Item Name: Aft Crosstube - High 407

Reference: REWORK PER ECN 15-557

DRAWN	RF		
CHECKED	RF		
MFG. APPR.	RF		
APPROVED	RF		
DE APPR.	RF		
DATE	15.03.20		
DART AEROSPACE LTD HAWKESBURY, ONTARIO, CANADA DRAWING NO. D407-667-245 TITLE CROSSTUBE ASS'Y (407 HIGH AFT) SCALE NTS REV. G SHEET 1 OF 4 COPYRIGHT © 2002 BY DART AEROSPACE LTD THIS DOCUMENT IS PRIVATE AND CONFIDENTIAL AND IS SUPPLIED ON THE EXPRESS CONDITION THAT IT IS NOT TO BE USED FOR ANY PURPOSE OR COPIED OR COMMUNICATED TO ANY OTHER PERSON WITHOUT WRITTEN PERMISSION FROM DART AEROSPACE LTD.

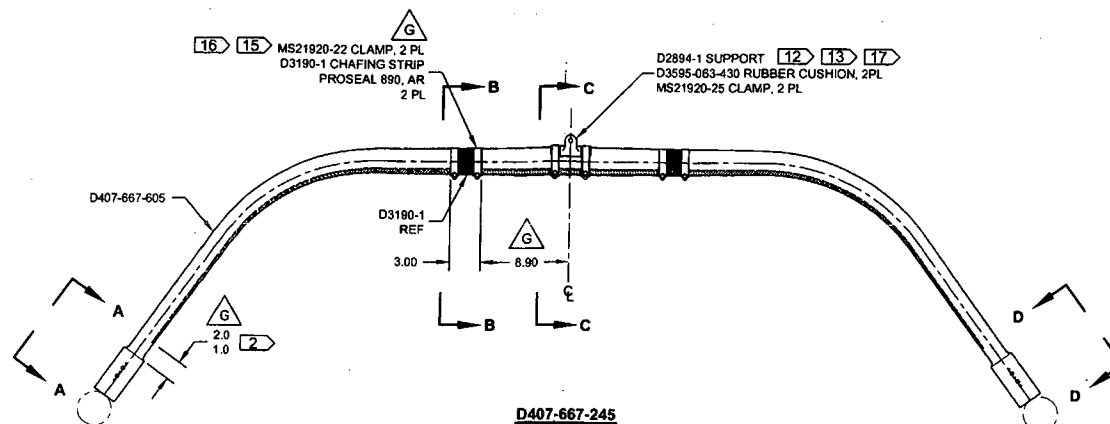
G	INCRP. DEO'S D407-667-245-F1/F2 (ZN D8-1, A8-1, D5-2, B6-2, C6-2); 8.90 WAS 8.53 (ZN D5-2); TORQUE REDUCED FOR CHAFING SHIELD (ZN A8-1); FINISH REVISED TO ALLOW MANUFAC. FLEXIBILITY (ZN C8-1)	RF	15.03.20
F	REFORMAT NOTES TO NEW STANDARDS (ZN B8-1); RELOCATED FLAG # 6 (ZN A8-3) PER NCR 210; REMOVED REF. & ADD TOLERANCES (ZN C6-3, C4-3 & D2-3)	RF	08.11.06
E	8.02 AND 8.53 WERE 8.40 AND 8.90 (ZN D5-2); REORGANIZED VIEWS AND REFORMATED DRAWING TO CURRENT STANDARDS. REASONS: CLAMPS MOVED 0.375 TOWARD CL TO ELIMINATE INTERFERENCE WITH AIRCRAFT MOUNTS. REFERENCE: PAR#08-21 AND ECN#1225	MB	08.07.24
D	ADD VIEW FOR OEM SKID HOLES, ROTATE ORIENTATION OF CLAMPS SECTION F-F, REMOVE -851 ABRASION STRIP, ADD MAGNOBOND 6398, ADD CUSHION	PH	07.02.07
C	ADD HOLES AND NUT PLATES FOR COMPATIBILITY WITH BHT/AA SKIDTUBES	PH	05.07.26
B	ADD CHAFING SHIELD	CP	03.05.21
A	NEW ISSUE	CP	02.05.13
REV.	DESCRIPTION	BY	DATE
DESIGN	RF

D407-667-245
ASSEMBLY DETAIL
(VIEW LOOKING FWD)

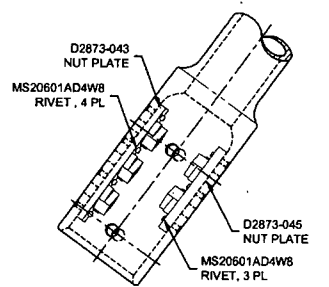
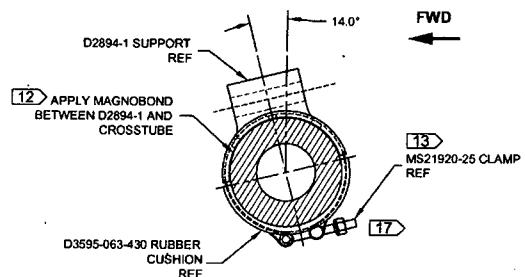
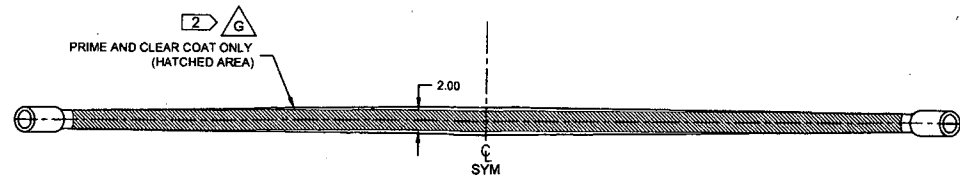
NEEDS TO BE REWORKED PER ECN 15-557

REMOVE CHAFFING SHIELDS AND CLAMPS (MS21920-22)
AND SCRAP

Paint B # 132024
REPLACE WITH NEW PER NEW DRAWING REV G

1- Install chaffing shield as per D407-667-245 using DT10096 to establish 8.90
dimension. Top holes should be facing up.

****Ensure chaffing is to be position "overlap" AFT****
